# Wisconsin Department of Transportation

**Proposal 12: 2195-03-70, WISC 20180 009**  
**West Wells Street, City of Milwaukee**  
**Milwaukee River Bridge B-40-544**  
**USH 18**  
**Milwaukee County**

This is Addendum No. 02, which provides for the following:

Addendum No. 02  
ID 2195-03-70  
Revised Sheet 91  
December 7, 2017

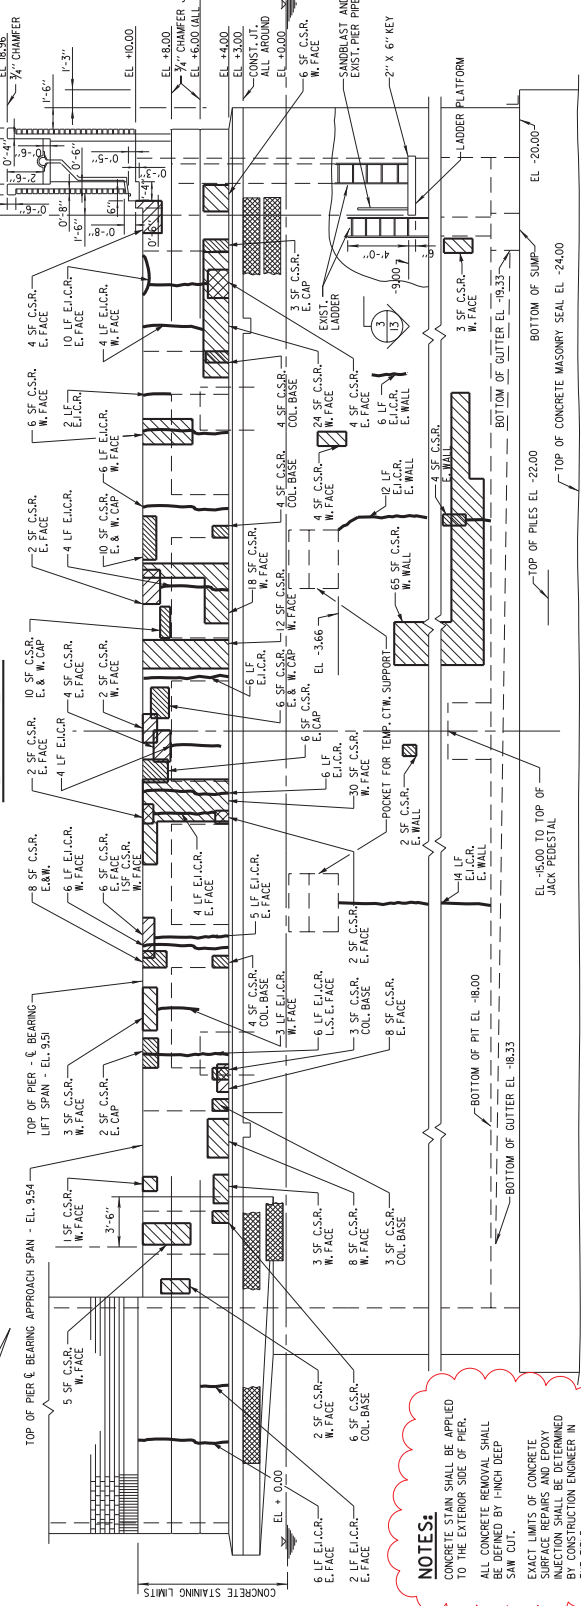
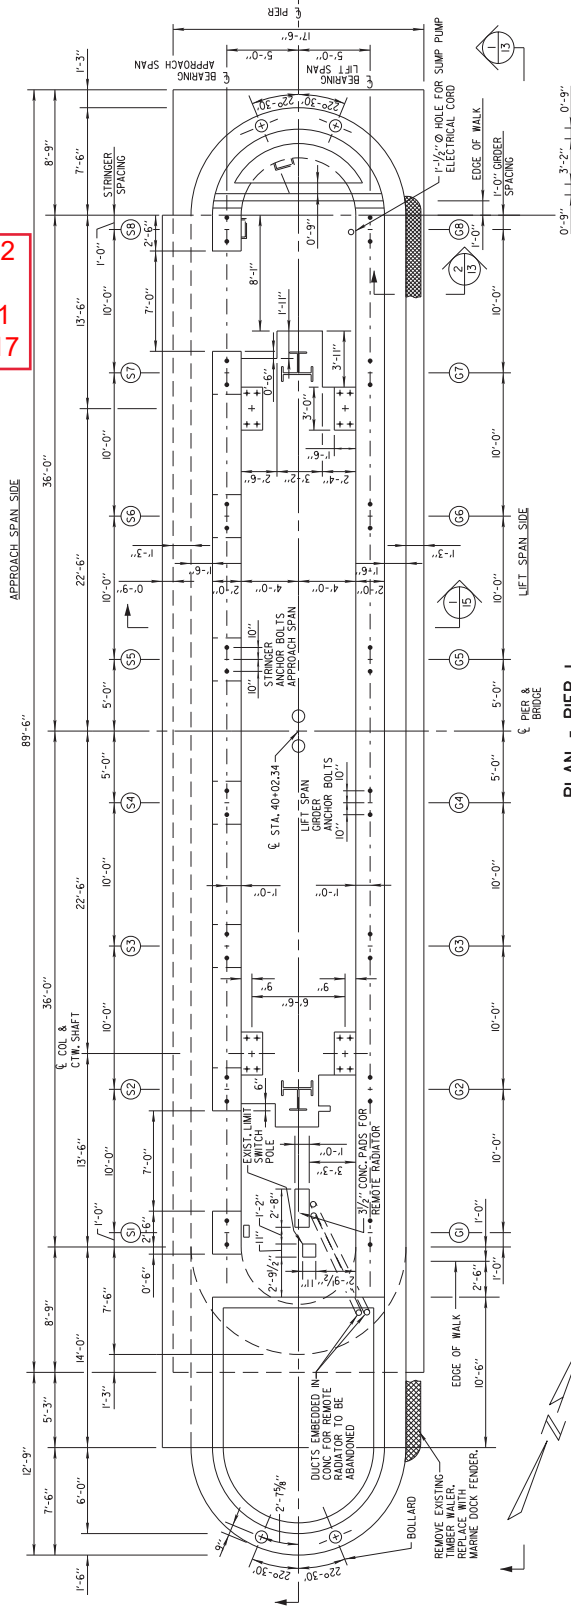
Revised Plan Sheets	
Plan Sheet	Plan Sheet Title (brief description of changes to sheet)
91	PIER 1 (Deleted note about clean up in east and west pier pit area)
157	ONE-LINE DIAGRAM (Changed Non Fused Disconnect to Fused Disconnect)
158	HPU RELAY CABINET (Changed HPU Relay Cabinet Size)
159	EXISTING CONTROL CONSOLE (Added New Switch for Remote Operation)

NO.	DATE	REVISION	BY
1	02/25/17	REMOVED NOTE	JDT

Addendum No. 02  
ID 2195-03-70  
Revised Sheet 157  
December 7, 2017

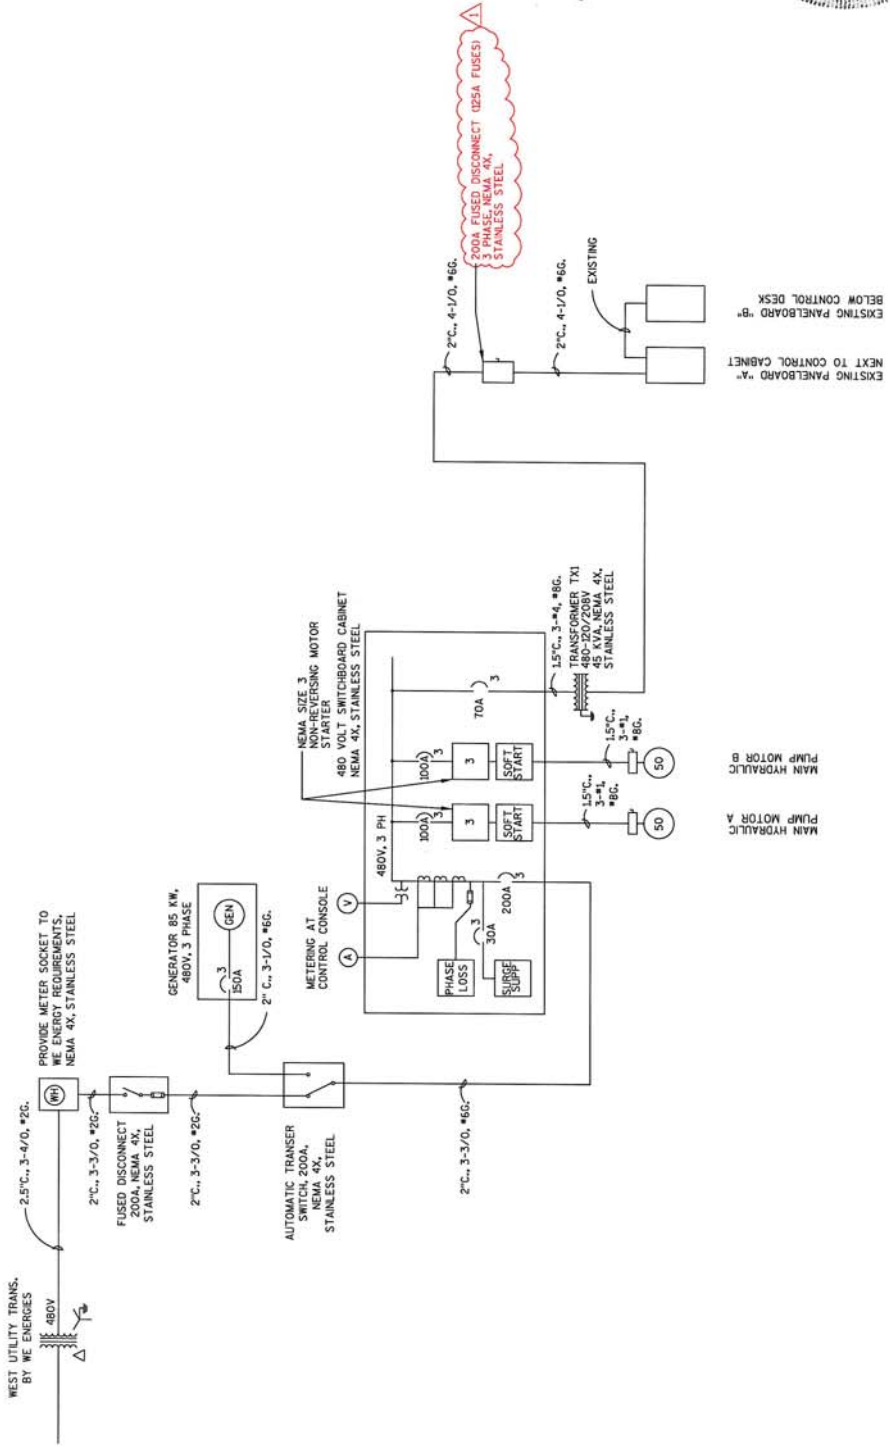
NO.	DATE	REVISION	BY
1	12/5/17	DISCONNECT SWITCH	JOS

Addendum No. 02  
ID 2195-03-70  
Revised Sheet 158  
December 7, 2017

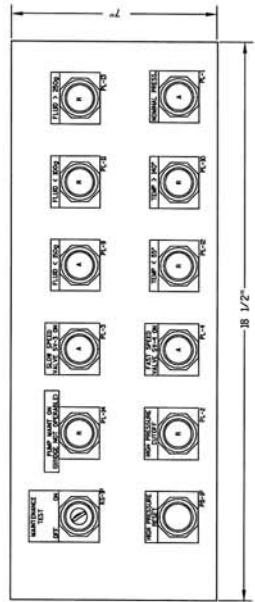
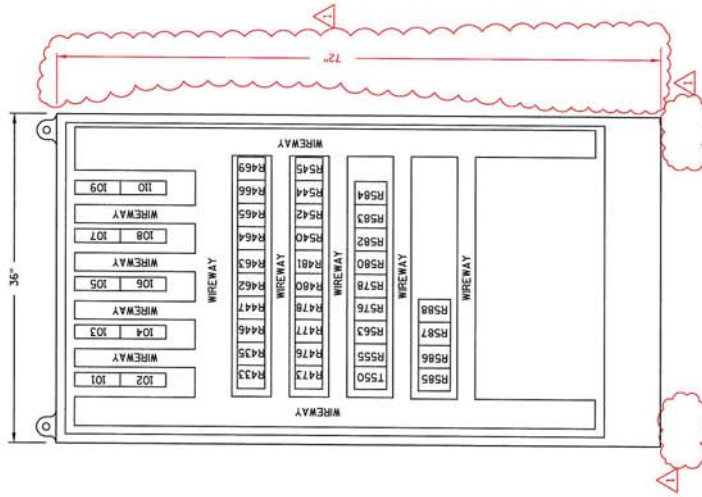
NO. DATE	REVISION	BY
12/25/17	CABINET SIZE CHANGE	JCS
STATE OF WISCONSIN DEPARTMENT OF TRANSPORTATION		
STRUCTURE B-40-544		
DRAWN BY	CHKD. BY	PLANS JCS
HPU RELAY CABINET		SHEET 158 OF 158

The Relay cabinet shall be of neat, substantial construction, arranged as shown on the plans. It shall be fabricated from not less than No. 12 gauge stainless steel properly formed, and suitable reinforced by steel angles to provide adequate strength. The door shall be 12 gauge stainless steel. The cabinet shall be Hoffman Engineering Co. catalog number A- A723612LP3PT with back panel or equal by Hammond Industries. The general arrangement may be varied to fit specific equipment used. The cabinet dimensions shall not be exceeded. The cabinet shall have a nameplate attached to the left hand door. Nameplates shall be not less than 1 inch high and shall be attached with stainless steel screws. Cabinet shall be mounted where shown on the plans and secures to the support shelf bracket using 3/4" stainless steel bolts and hardware.

CABINET SHALL BE HOFFMAN ENGINEERING  
PANEL NO. 7580L3PPT WITH BACK  
PANEL OF APPROVED EQUAL.

Addendum No. 02  
ID 2195-03-70  
Revised Sheet 159  
December 7, 2017

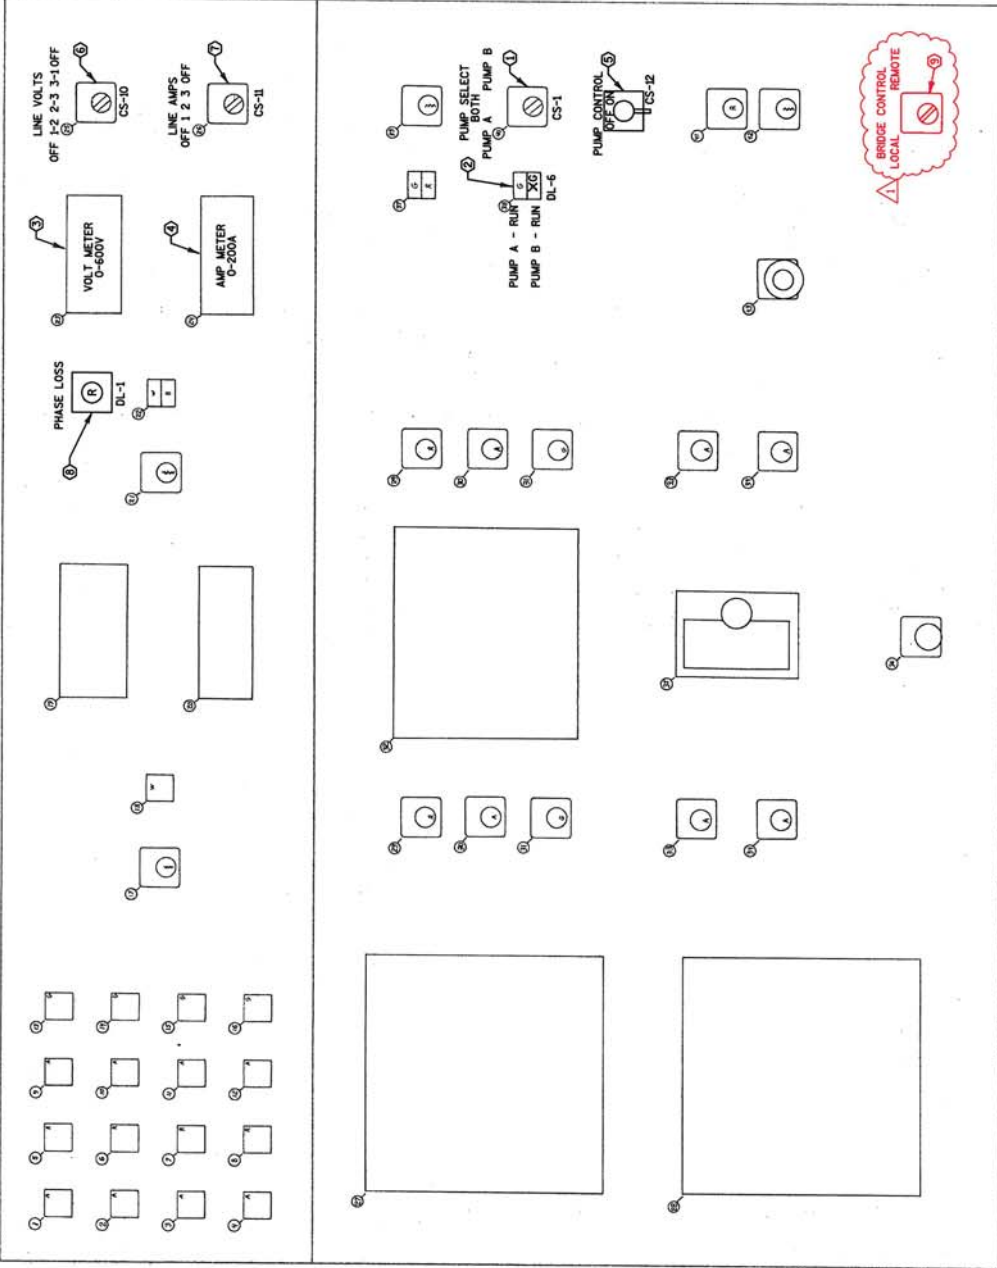
NO. DATE	ADD SELECTOR SWITCH	JOS
	REVISION	BY

- 1) REMOVE EXISTING SWITCH, PROVIDE NEW SWITCH AND NAMEPLATE.
- 2) REMOVE EXISTING PILOT LIGHTS AND PROVIDE NEW PILOT LIGHTS AND NAMEPLATE.
- 3) PROVIDE NEW ILLUMINATED WESLER VOLTMETER 0-600V, WESLER AMP METER 0-200A, WESLER DIGITAL CLOCK AND BUZZER IN EXISTING RELAY CABINET.
- 4) CALIBRATE AMP METERS TO READ CORRECT AMPS AT 480V. CONNECT TO METERS 480V SWITCHBOARD CABINET, BEING EXISTING CT'S IN EXISTING RELAY CABINET.
- 5) PROVIDE NEW SWITCH WITH NAME PLATE "OFF - ON".
- 6) PROVIDE NEW VOLTAGE PHASE SELECTOR SWITCH AND NAMEPLATE.
- 7) PROVIDE NEW AMPMETER SELECTOR SWITCH AND NAMEPLATE.
- 8) PROVIDE NEW DESK LIGHT FOR PHASE LOSS MONITOR AND NAMEPLATE.
- 9) PROVIDE NEW SWITCH WITH NAME PLATE "BRIDGE CONTROL" "LOCAL-REMOTE".
